STAFF REPORT ACTION REQUIRED

Sign Variance - 155 Wellington St W

Date:	February 9, 2008
To:	Toronto and East York Community Council
From:	Director, Toronto Building, Toronto and East York District
Wards:	Ward 20 – Trinity-Spadina
Reference Number:	P:\2009\Cluster B\BLD\Toronto and East York\2009TE015

Attachment 1:

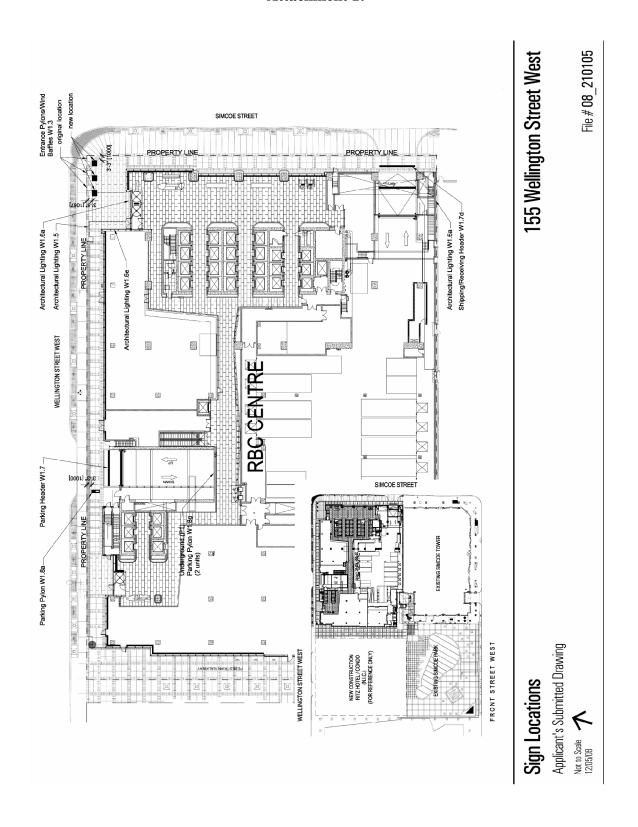
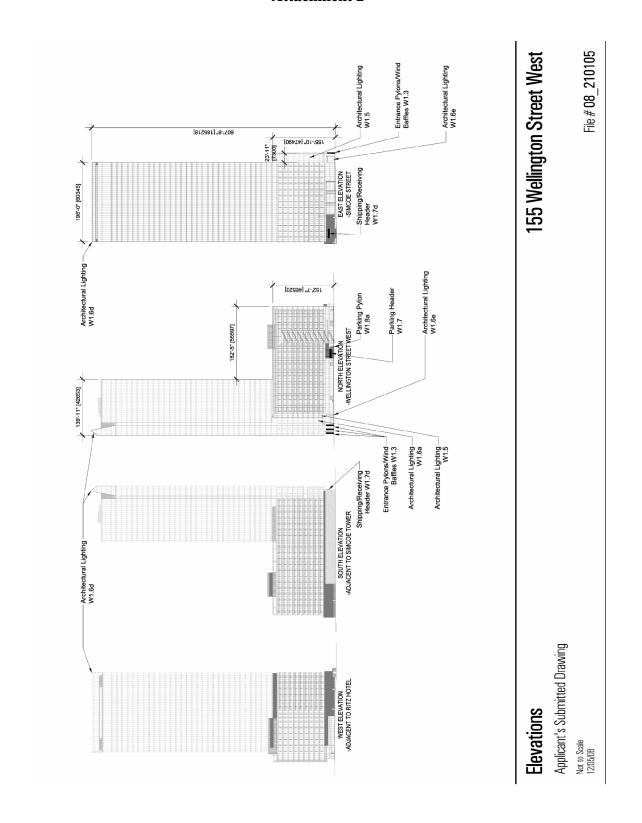
Sign By-law Section and Requirements	Applicant's Proposal	Required Variance
1. Chapter 297-2-Definitions	The three proposed pedestal signs located at the northeast corner of the property would be 1.09m wide and 6.0m high.	The 6.0m sign height would exceed by 1.5m, the maximum 4.5m sign height permitted for a pedestal sign.

2. Chapter 297-10D (12)	The three pedestal signs at the northeast corner of the property would set back 1.0m from the north property line and would set back less than 6.0m from the intersection of two property lines.	The 1.0m sign set back from the property line would be 1.0m less than the required 2.0m. Also, the pedestal signs would not meet the 6.0m set back requirement from the intersection of two property lines.

3. Chapter 297-10D (12)	A total of four pedestal signs would be located on this lot.	The Municipal Code permits a maximum of two pedestal or ground signs per lot, provided two frontages of the lot are greater than 30.0m in length.

4. Chapter 297-10 B (2) & 10 D(12)	The illuminated pedestal sign located at the west portion of the Wellington Avenue West frontage of the property would contain an electronic message display panel to disperse information concerning under ground public parking.	A sign containing an electronic message display copy is not permitted.

5. Chapter 297-10D & 9D	The proposed over head fascia sign would be located over the entrance and exit ramps for the under ground parking garage along Wellington Avenue West frontage of the building.	The proposed sign is not a defined type sign in the Municipal Code.

6. Chapter 297-10D & 9D	The proposed over head fascia sign would be located over the shipping and receiving docks along the Simcoe Street frontage of the building.	The proposed sign is not a defined type sign in the Municipal Code.

With respect to the first and second variances are required because the proposed pedestal signs located at the northeast corner of the property would exceed the permitted 4.5m height by 1.5m and they do not set back 2.0m from the property line and 6.0m from the intersection of two property lines. In this case, the proposed height and set back location was established after conducting a Pedestrian Wind Study for the Simcoe Centre-Commercial Tower at 155 Wellington Street West. The proposed pedestal signs at this location are functional architectural features to act as Wind Baffles. It is staffs opinion that the proposed height and sign set back would not obstruct or block the view corridors or the sightlines for the motorists, cyclists or the pedestrians.

The third variance is required because Municipal Code permits only two pedestal signs provided two frontage of the lot are greater than 30.0m in length. In this case, three pedestal signs at the northeast corner of the property are the functional architectural features to act as Wind Baffles. The pedestal sign is required to display information about the under ground parking garage in the building. The purpose of limiting the number of pedestal signs or ground signs on a lot is to avoid sign clutter. In this instance, the property frontages are long enough to accommodate proposed signs without creating a sense of clutter.

The fourth variance is required because the pedestal sign at the west portion of Wellington Avenue West frontage would contain an electronic message display panel. In this case, the electronic message display panel is very small and it would display daily and hourly rates and the information about the availability of the parking space in the under ground parking garage in the building. It is staff's opinion that the sign would not adversely impact the building or the streetscape.

The fifth and sixth variances are required because the overhead signs on the north and east elevations of the building do not meet the definition of a fascia sign. As defined in the Municipal Code, a fascia sign is required to be mounted wholly against the wall or parapet wall of a building. In this case, the proposed signs closely resembles fascia signs except that they would be attached against the overhead panels instead of against the wall or parapet wall of a building. These variances are technical in nature. It is staff's opinion that the overhead signs on the north and east elevations are designed, sized and positioned to complement the building facades, surrounding uses and the streetscape.
